Identification cards — Test methods —
Part 6:
Proximity cards

AMENDMENT 1: Additional PICC classes

Amendment 1 to ISO/IEC 10373-6:2011 was prepared by Joint Technical Committee ISO/IEC JTC 1, *Information technology*, Subcommittee SC 17, *Cards and personal identification*.

Figure 1 — Calibration coils 1 and 2

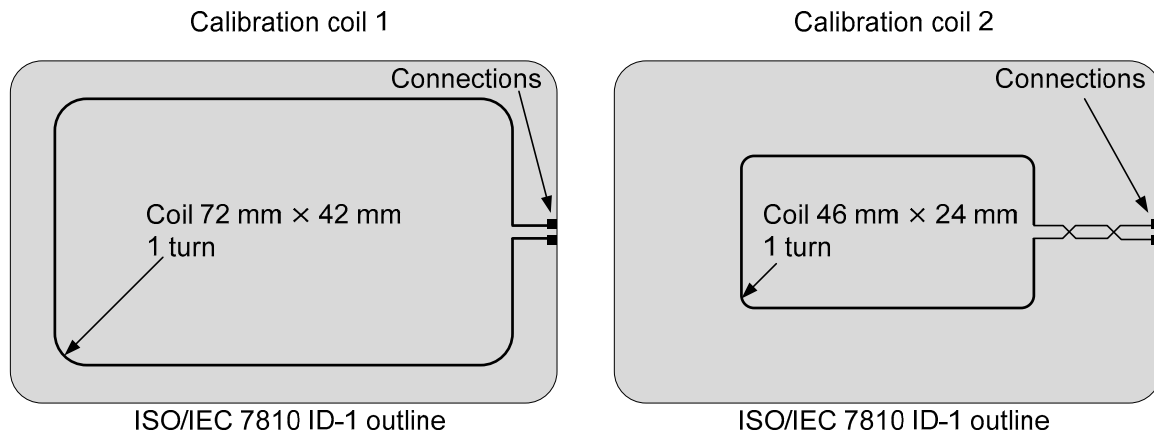
Replace 5.2 and its subclauses by the following:

The calibration coil card shall consist of an area which has the height and width of an ID-1 type defined in ISO/IEC 7810:2003 containing a single turn coil concentric with the card outline (see Figure 1).

The coil on the calibration coil card shall have one turn. Relative dimensional tolerance shall be $\pm 2\%$.

The outer size of the calibration coil 1 shall be 72 mm $\times$ 42 mm with corner radius 5 mm.

The open circuit calibration factor for the calibration coil 1 is 0,318 V (rms) per A/m (rms) [Equivalent to 900 mV (peak-to-peak) per A/m (rms)].

The outer size of the calibration coil 2 shall be 47 mm $\times$ 24 mm with corner radius 2 mm.

The open circuit calibration factor for the calibration coil 2 is 0,118 V (rms) per A/m (rms) [Equivalent to 333 mV (peak-to-peak) per A/m (rms)].

The coil shall be made as a printed coil on printed circuit board (PCB) plated with 35 μ m copper. Track width shall be 500 μ m with a relative tolerance of $\pm 20\%$. The size of the connection pads shall be 1,5 mm $\times$ 1,5 mm.

Figure 2 — Test set-up (principle)

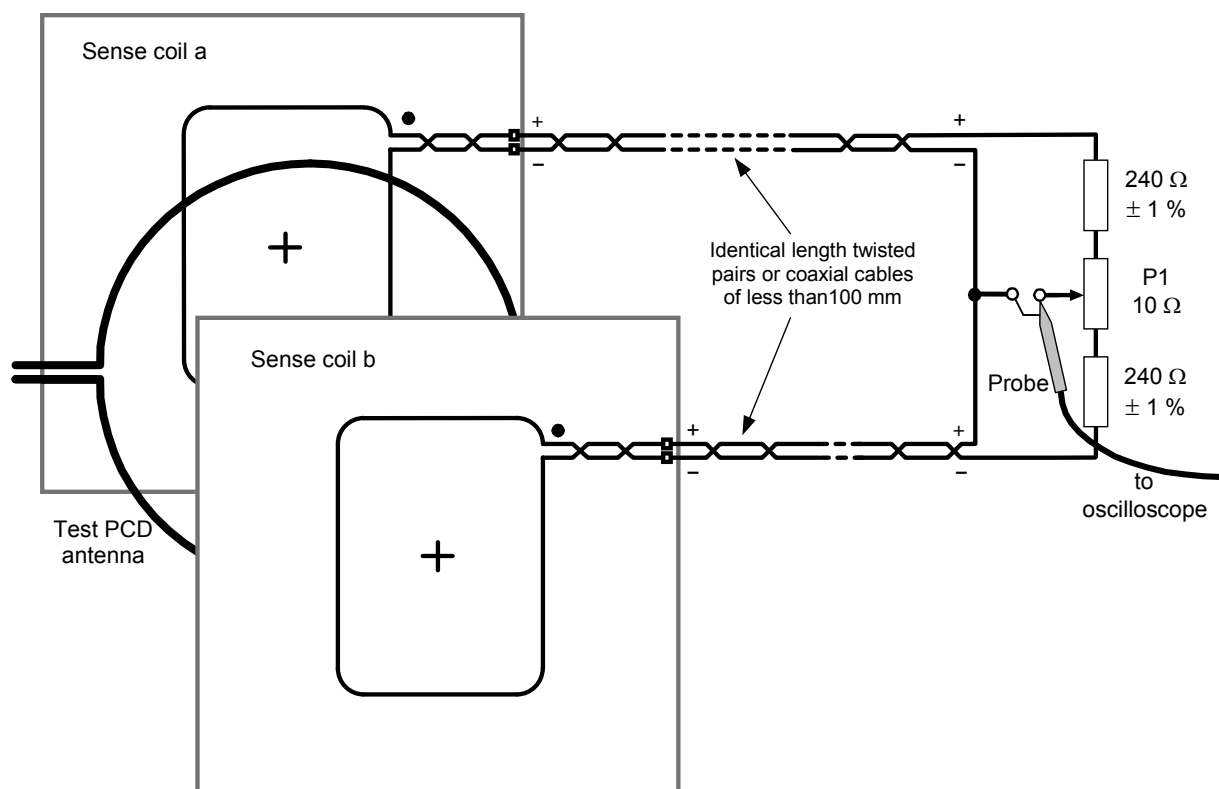
Replace 5.3 and its subclauses by the following:

Two test PCD assemblies are defined:

- Test PCD assembly 1 for PICCs of classes 1, 2 and 3 and for PICCs which do not claim compliance with a class;
- Test PCD assembly 2 for PICCs of classes 4, 5 and 6.

Each test PCD assembly shall consist of a circular test PCD antenna and two parallel sense coils: sense coil a and sense coil b. The test set-up is shown in Figure 2. The sense coils shall be connected such that the signal from one coil is in opposite phase to the other. The $10\ \Omega$ potentiometer P1 serves to fine adjust the balance point when the sense coils are not loaded by a PICC or any magnetically coupled circuit. The capacitive load of the probe including its parasitic capacitance shall be less than $14\ \text{pF}$.

NOTE 2 In order to avoid any unintended misalignment in case of an unsymmetrical set-up the tuning range of the potentiometer P1 is only $10\ \Omega$. If the set-up cannot be compensated by the $10\ \Omega$ potentiometer P1 the overall symmetry of the set-up should be checked.
